CITY OF TULARE PLANNING COMMISSION STAFF REPORT

OAK CREEK 3 - TENTATIVE SUBDIVISION MAP

SITE PLAN REVIEW COMMENTS

PROJECT: Site Plan Review Application No.: 1823 (Oak Creek No. 3)

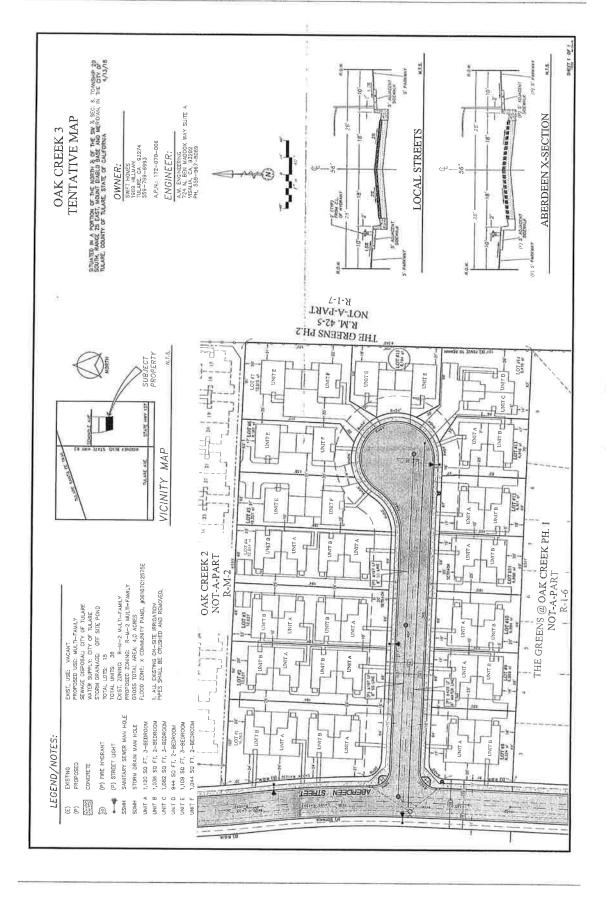
City Standard Detail No. 7130 (eccentric cul-de-sac) is dimensioned for a parkway strip configuration (11 feet from curb face to right-of-way line). Please adjust radial dimension on cul-de-sac bulb to reflect the proposed adjacent sidewalk configuration (10 feet from curb face to right-of-way line).

Plan view dimensions for Aberdeen Street (58 feet from right-of-way to right-of-way) does not match cross section shown (56 feet from right-of-way to right-of-way). Please adjust plan view drawing to match dimensions shown in the Aberdeen Street cross section.
